IREDELL COUNTY HEALTH DEPARTMENT

THE LINKS AT MALLARD HEAD

IMPROVEMENT PERMIT / AUTHORIZATION TO CONSTRUCT / OPERATION PERMIT / EXISTING SYSTEM INSPECTION

PERMIT# 124419 PIN# 4636-76-3226.003 4636 66 9278 DATE 12/6/04

INITIAL SITE SKETCH

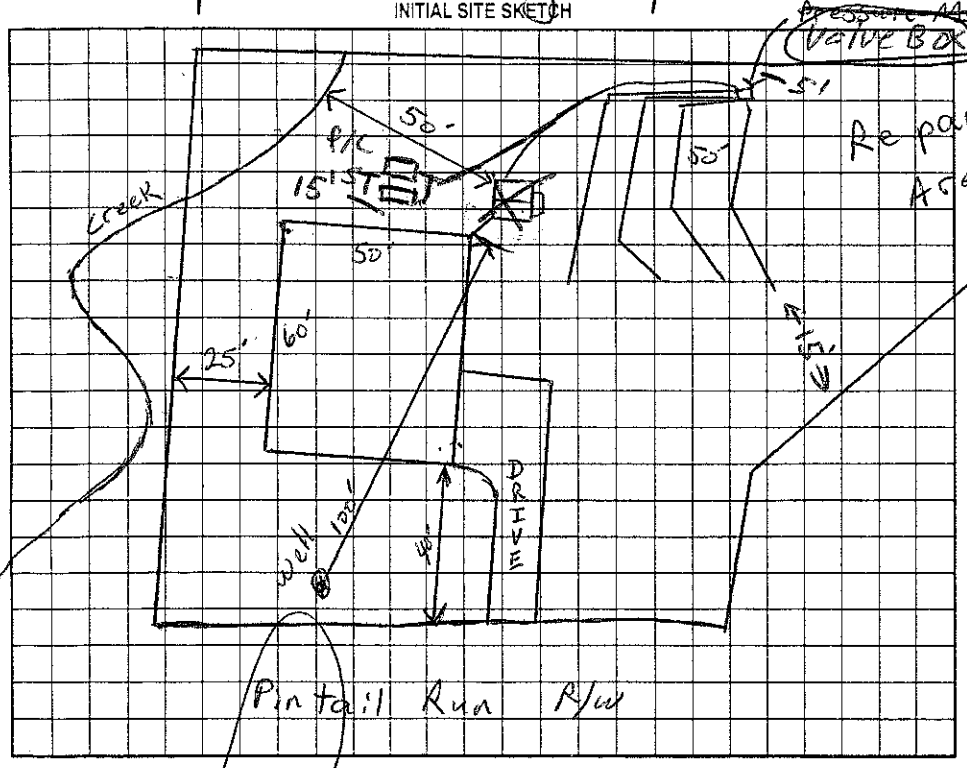
Comments:/Conditions:
36" OR 3FOC
1"=50'
9/20/06 Reviewed site plan & Floor plans, essentially in compliance with original permit.

Comments:/Conditions:
Keep tanks 15Ft (sideslope) or 25Ft upslope of basement

Drawing checked 11/30/07
Tanks were checked previously by Joe Alexander information not recorded.
Tanks were Covered
Pressure set 11/30/07

12/6/07 Inspection of house shows doors where openings are supposed to be cased openings making total bedrooms of 5 including the bonus room doorways need to be cased openings as shown on original plans. AC

12/10/07 doorways have been cased making total of 3 bedrooms home has been inspected A.C.
